Subject: Oconee Nuclear Station
Docket Numbers 50-269, 270, and 287
Response to Request for Additional Information
Pertaining to the License Amendment Request (LAR)
for RPS/ESPS Digital Upgrade
Technical Specification Change (TSC) Number
2004-09, Supplement 1

**Attachment 1 – Non Proprietary
Duke Response to Request for Additional Information (RAI)
Oconee Nuclear Station License Amendment Request
for RPS/ESPS Digital Upgrade**

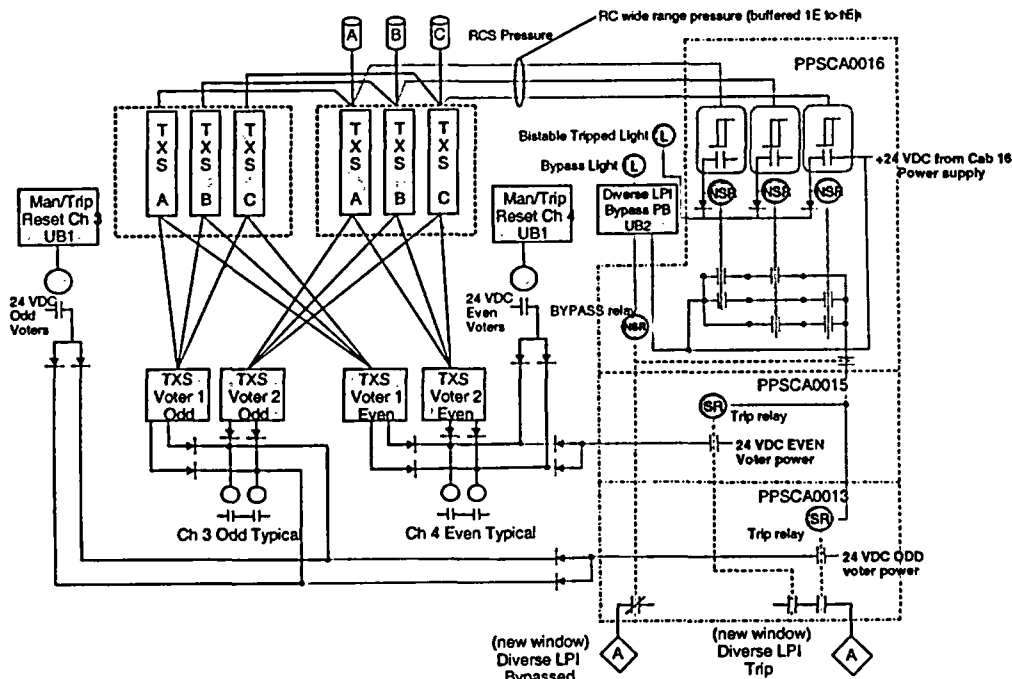
The submittal, in response to plant specific requirement 12, as listed in the NRC staff SER on the TXS Topical Report, stated that a plant specific risk informed Defense-in-Depth and Diversity assessment to justify eliminating the need to install the diverse LPI actuation in early 2005. Please provide that assessment, keeping in mind that NRC has neither reviewed or approved the EPRI report 1002835, "Guideline for Performing Defense-in-Depth and Diversity Assessments for Digital Upgrades."

During the August 17, 2005, RAI meeting, the NRC reviewer requested Duke to provide the design details for the diverse LPI actuation system. Duke provided the design requirements for that system during a November 17, 2004 Duke/NRC meeting. NRC concurred in that meeting as documented in NRC letter dated January 3, 2005 that the

The DLPIAS will use analog bi-stable trip units and 2 out of 3 relay logic actuated on Low RCS Pressure. See Figure below.

2. Automatic and manual actuation capability.
 - The DLPIAS will provide for automatic actuation of the Channel 3 and Channel 4 components. This includes LPI pumps, LPSW pumps and LPI Injection valves.

3. Actuate LPI on Low RC Pressure or High Reactor Building Pressure
 - DLPIAS will actuate only on Low Reactor Coolant Pressure. The basis for this is the DLPIAS is intended to provide automatic LPI injection to cover the case of the Large Break Loss of Coolant Accident (LBLOCA) in case the TXS has a common mode software failure. The loss of coolant pressure is the most appropriate indication that a LBLOCA has occurred.
